Modification Recommended Service Note

Supersedes:
E9902G-02A

Keysight i3070 In-Circuit Test System Installed with XTPB Cards

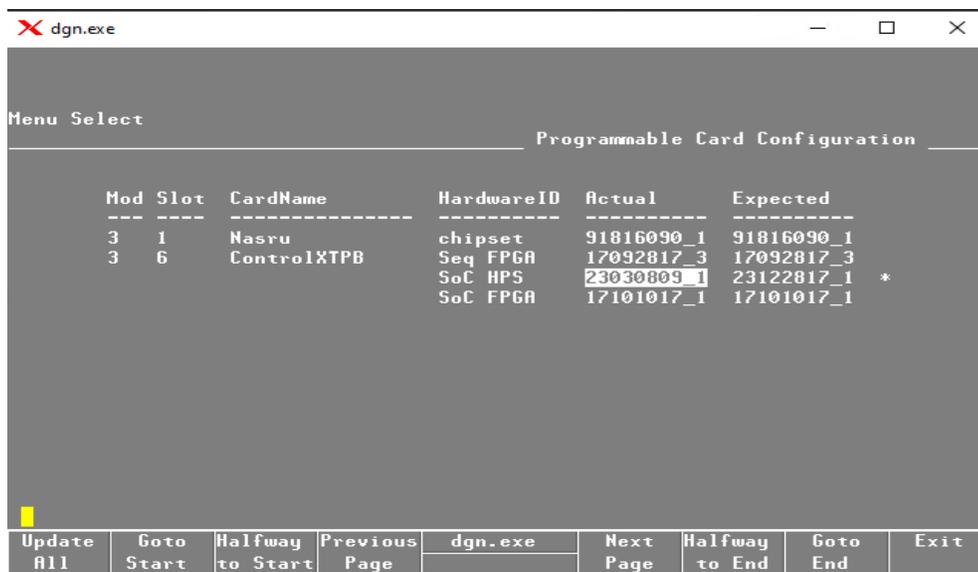
It is reported that certain analog powered tests may cause intermittent relay failures on double density (DD) pin cards in a i3070 system loaded with control XTPB cards.

A new firmware (version: v23122817_1) for XTPB card has been developed to address this issue. The new firmware can be downloaded from Keysight.com and the firmware update can be done by the user via DGN. Please note:
